SERVICE BULLETIN

Subject: A-2 Magnetic Clutch Power Plug Issue

Bulletin No. SB17-3

Figure 1

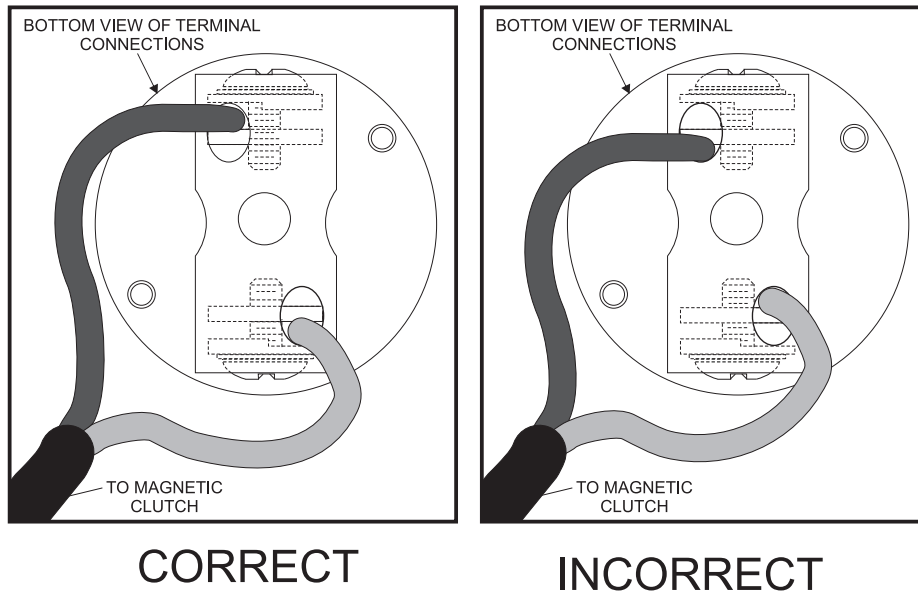
It has come to Brunswick's attention that part number 12-862163-000 Magnetic Clutch Power Plug, may be incorrectly assembled.

Please verify the terminals connections of the magnetic clutch.

Make sure that the clutch cables are secured between the metal plates in the plug and not toward the clear plastic part. Incorrect wiring may cause the magnetic clutch not to function as intended.
